050-0439-01

CURRENT TRANSFORMER ASSEMBLY REPLACEMENT

For TEKTRONIX® Type P6042 Current Probes All Serial Numbers

CURRENT TRANSFORMER ASSEMBLY REPLACEMENT

FIG.

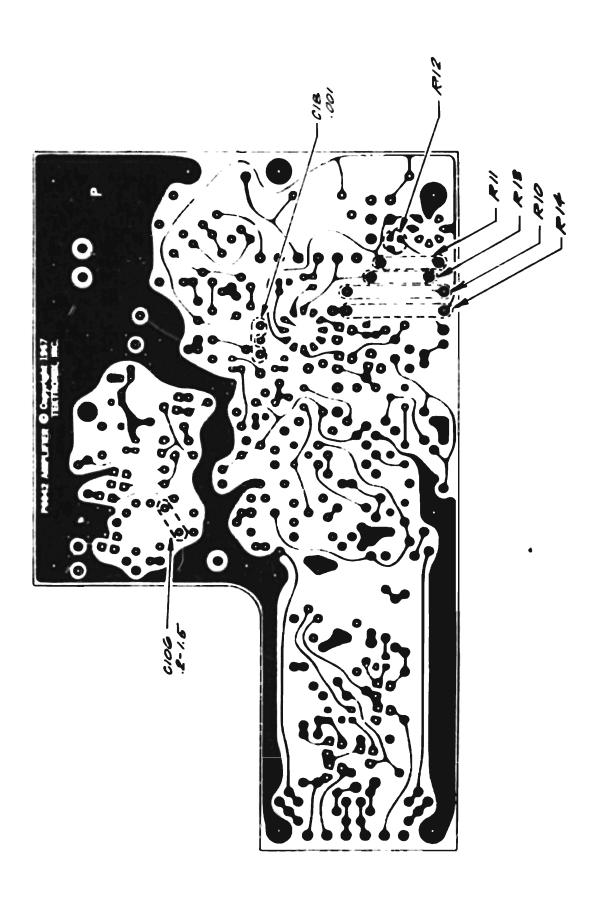
Refer to Fig. 1 for steps 5 through 10.

- () 5. Replace R10 with the resistor labeled 'R10' from the kit.
- () 6. Remove resistor R11 or R13, whichever one is present.
- () 7. Install resistor R11 or R13, whichever one is supplied with the kit.
- () 8. Replace R14 with the resistor labeled 'R14' from the kit.

FIG. 2

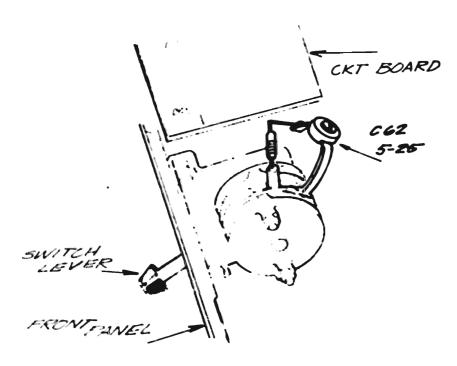
() 11. Refer to Fig. 2.

Replace the RC combination of R62 and C62, located on the DEGAUSS switch, with the 150Ω 1/8W resistor and the 5-25pF capacitor from the kit.
